**METROPOLITAN GOVERNMENT OF NASHVILLE AND DAVIDSON COUNTY**

**STAFF RECOMMENDATION**  
**207 Gentry Avenue**  
**October 15, 2014**

**Application:** New construction—addition and infill; Partial demolition  
**District:** Eastwood Neighborhood Conservation Zoning Overlay  
**Council District:** 06  
**Map and Parcel Number:** 08306020500  
**Applicant:** Andrew Beairo, Gentry Partners  
**Project Lead:** Melissa Baldock, melissa.baldock@nashville.gov

**Description of Project:** Application is to demolish a non-contributing addition and construct a new addition to a contributing structure (207 Gentry), three infill houses, four garages, and six rear lot cottages as part of a cottage development.

GENTRY AVENUE LOT 3 (EXISTING) MSD 9.15.14

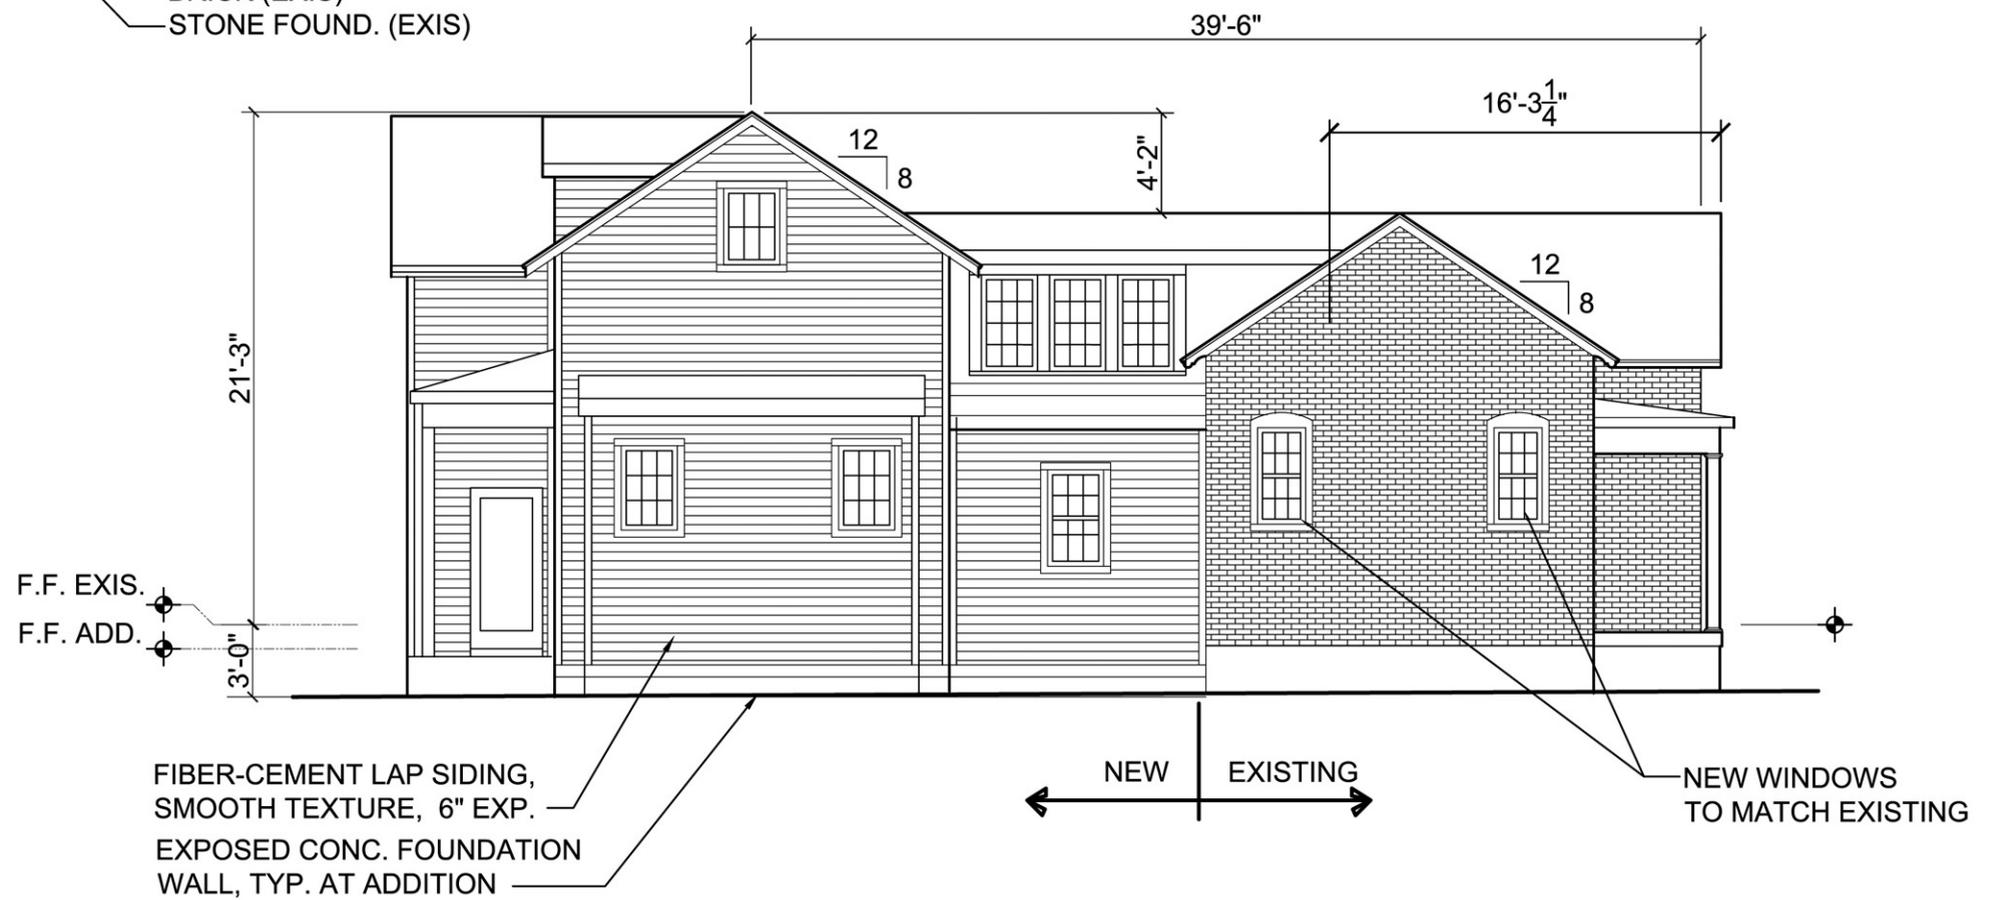
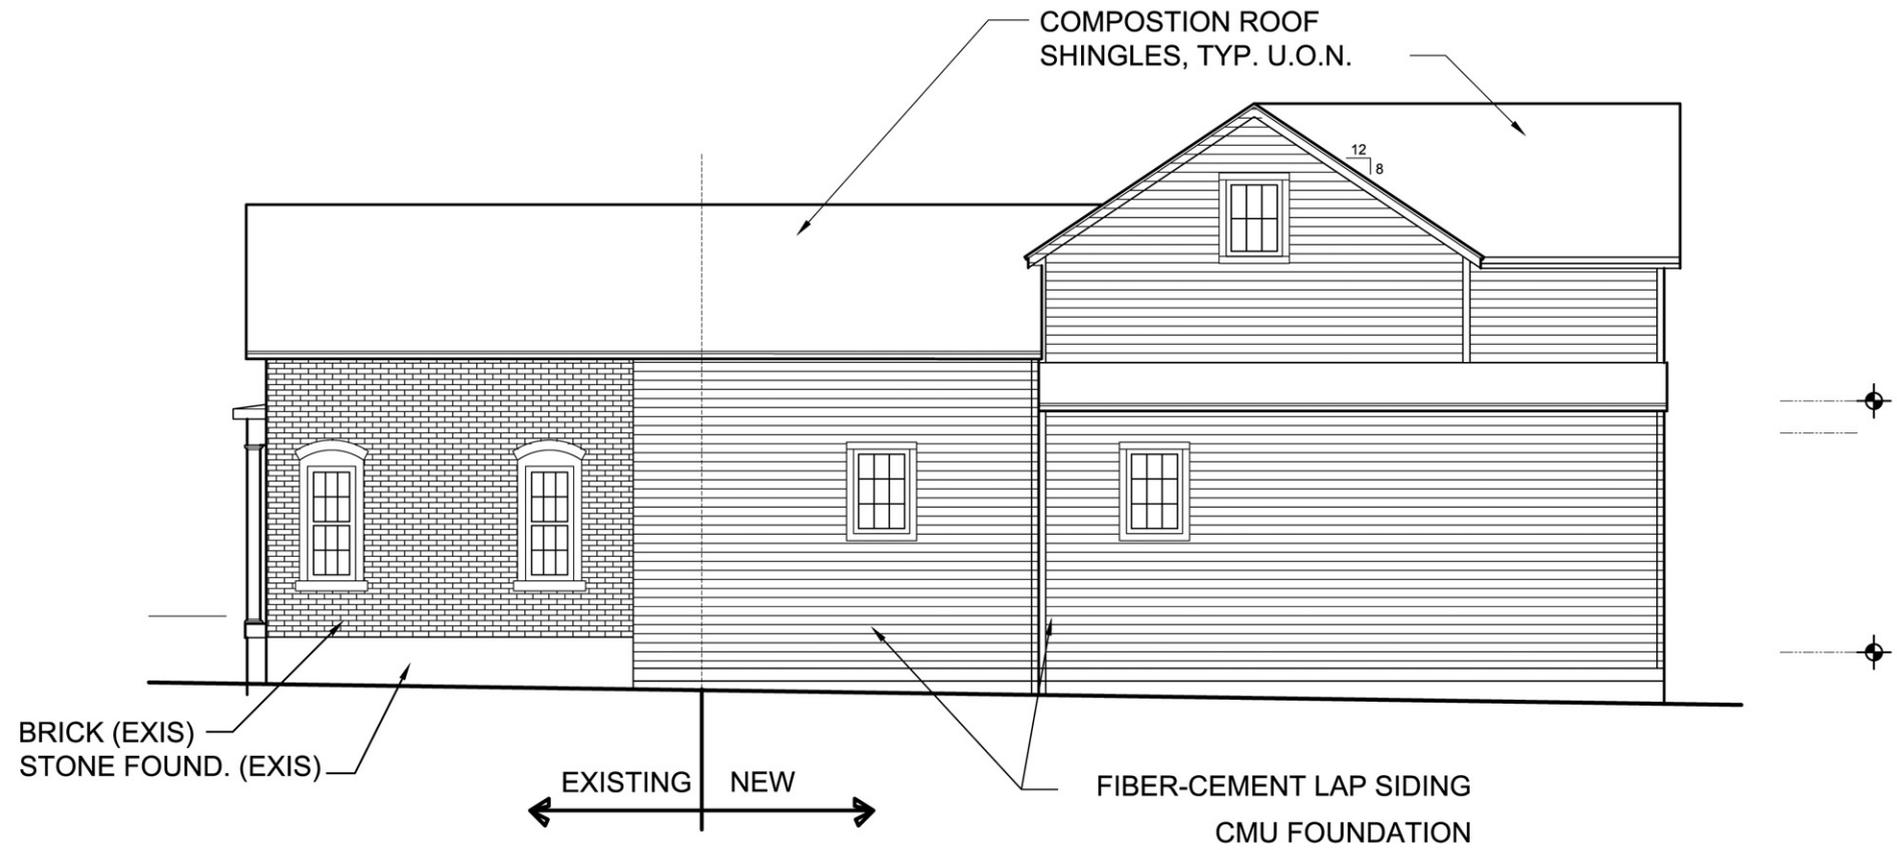
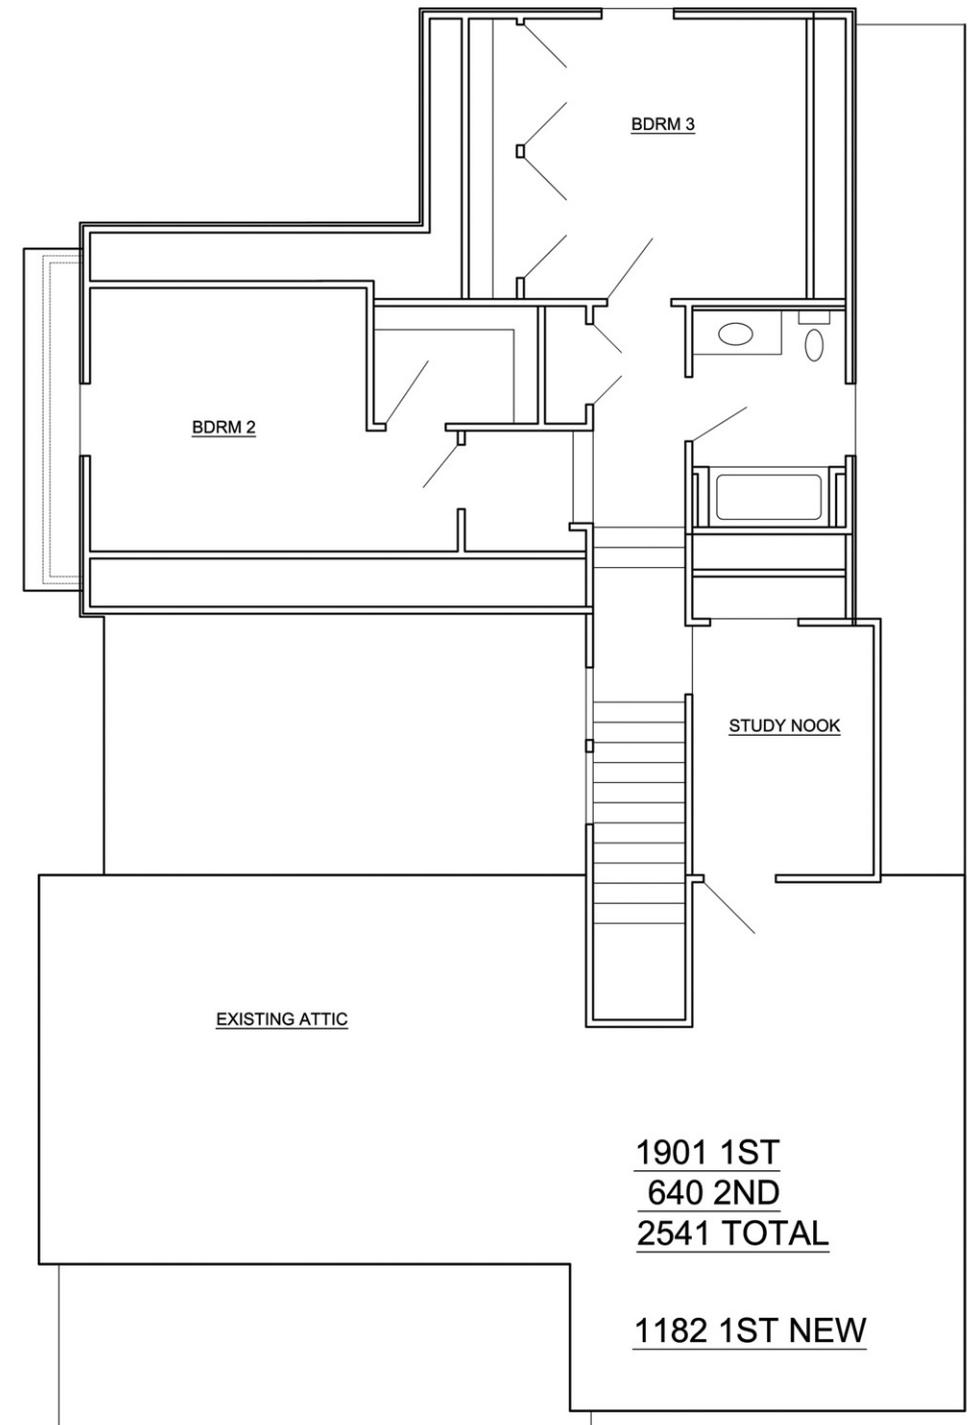
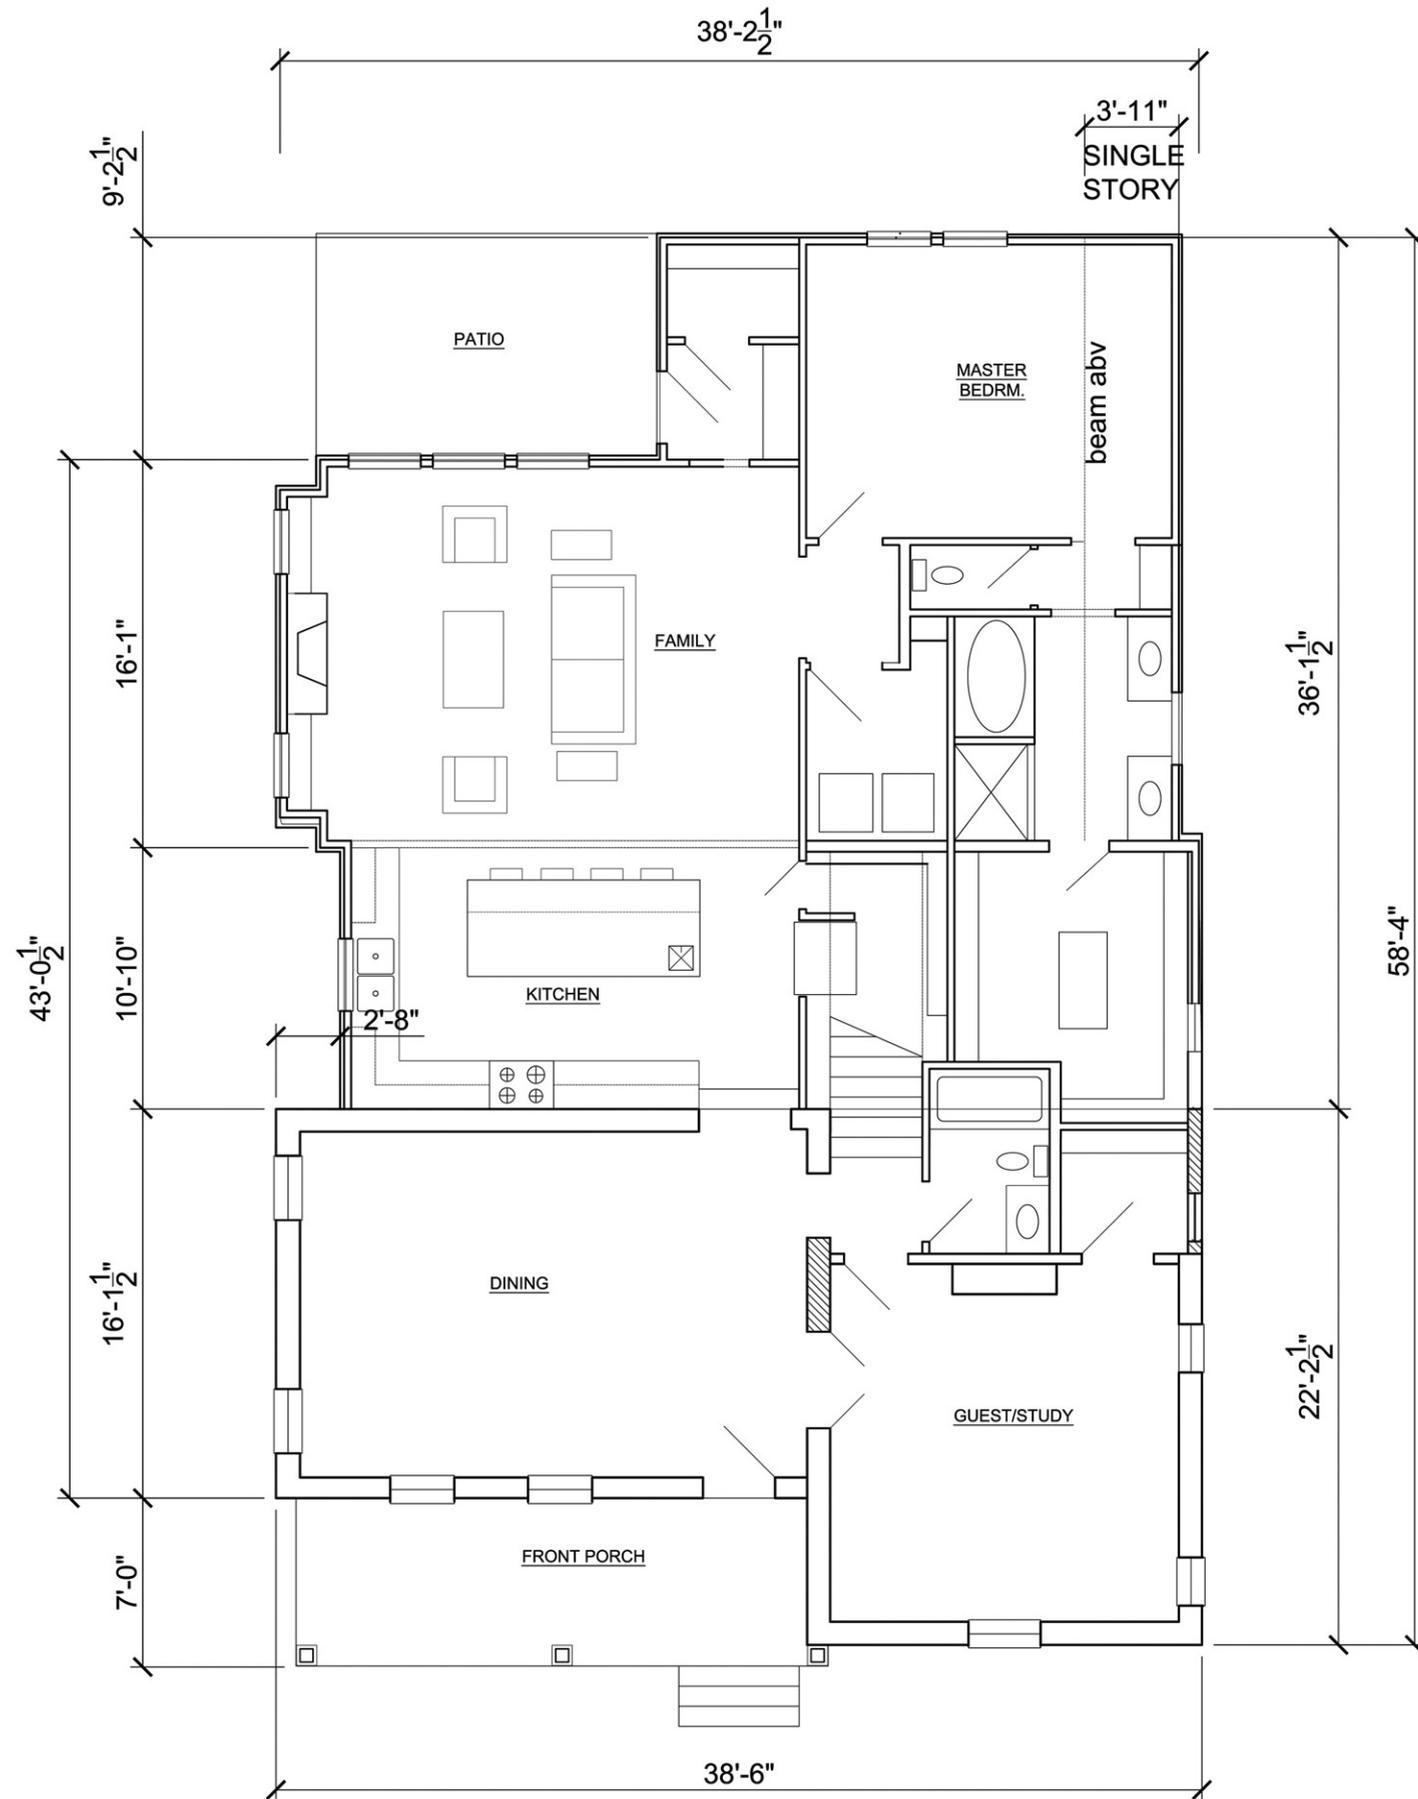
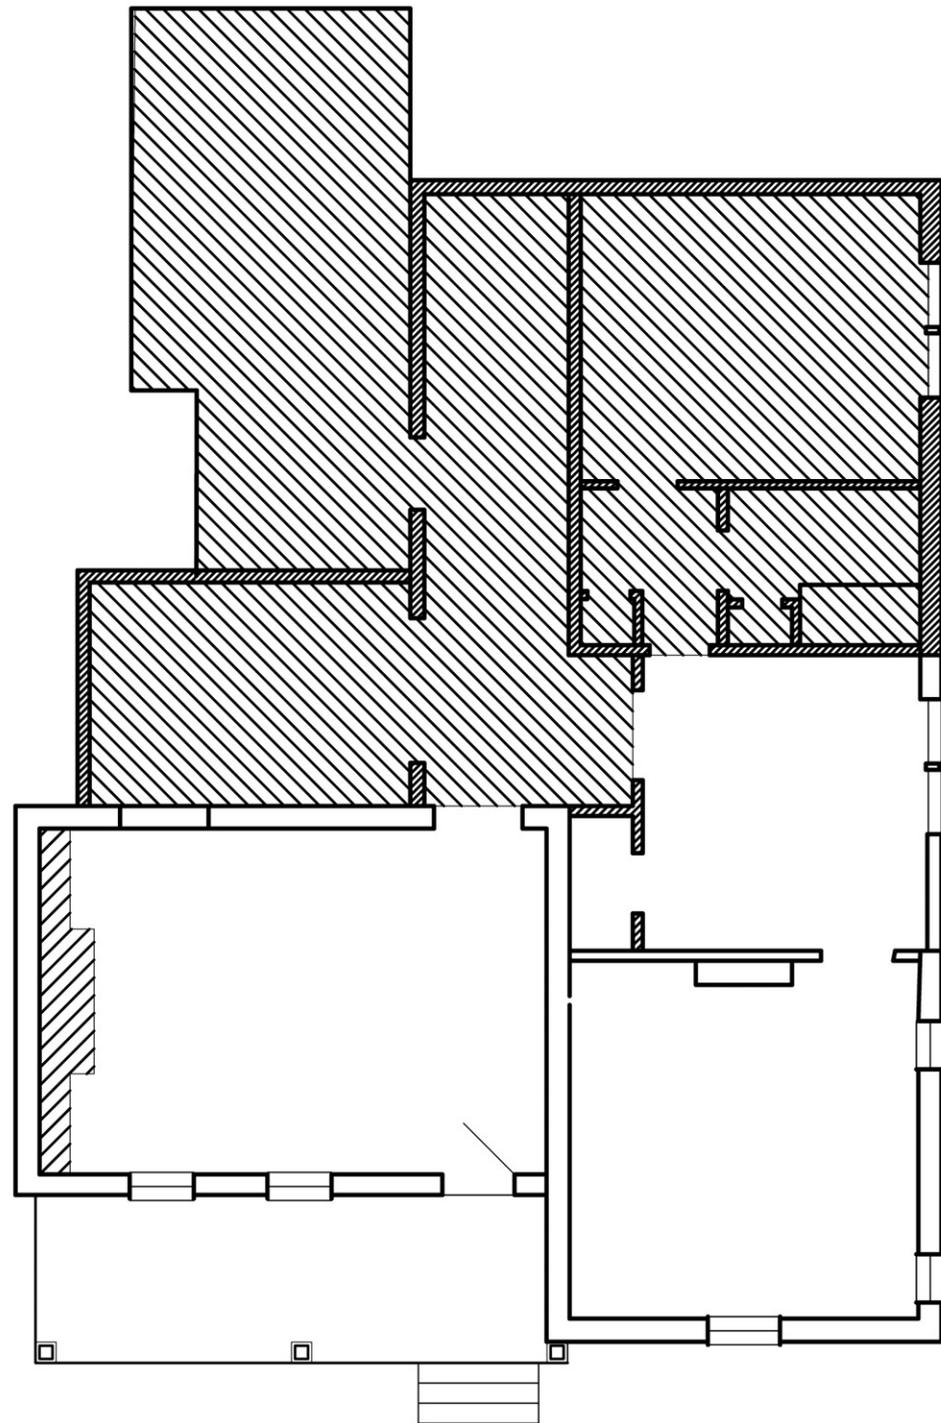
**Partial Demolition for Contributing House (207 Gentry):** The project involves demolishing a non-historic rear addition to 207 Gentry Avenue (Figures 4 & 5). Although the addition may be the same addition that appears on the 1957 Sanborn map, the addition’s materials, which include a concrete block foundation and non-historic siding, indicate that it was constructed outside the period of significance for the neighborhood. The addition does not contribute to the historic character of the house, and its demolition would not affect the house’s historic integrity. Staff therefore finds that the demolition of the non-historic addition meets Section III.B.2 for appropriate demolition and does not meet section III.B.1 for inappropriate demolition.

**Addition for Contributing House (207 Gentry):** The application includes constructing a new addition to the rear of the historic house at 207 Gentry Avenue. The addition will be located entirely behind the historic house. On the left side, the addition will step in two feet, eight inches (2’8”) from the rear wall of the historic house. On the right side,

the addition will not step in initially; instead it will match the line of the historic house. Although the Commission typically asks to have additions step in a minimum of two feet on both sides, in this case, the existing addition that is to be demolished does not step in. There is no existing historic back corner of the house to preserve, and the addition will be distinguished from the historic house by a change in material from brick to siding. Therefore an inset on the right side is not necessary. The addition does step in one foot (1') towards the back of the addition when it becomes two-stories in height.

The addition will tie into the back slope of the house's roof just below the house's ridge. Approximately forty feet (40') behind the front wall of the historic house, the addition will become approximately four feet (4') taller than the historic house. It will have a side-gabled roof form which will help minimize its visibility. Staff finds that the taller portion of the addition meets the design guidelines because of its location behind the house and because of the low original height of the home.

The addition will be distinguished from the historic house with a change in materials. It will have fiber cement lap siding. Staff asks that the siding have a maximum reveal of five inches (5"). The drawings indicate that the foundation will be CMU block, and staff asks that the block be split-faced. The materials for the windows and doors were not specified, and staff asks to review them prior to purchase and installation. The roof will be composition shingles, and staff asks to approve the roof color. The proportion and rhythm of openings on the addition generally meet the design guidelines. There is one expanse of over nineteen feet (19') of wall space without a door or window opening on the right façade, but because it is located at the back of the addition and will only be minimally visible from the public street, staff finds it to be acceptable.
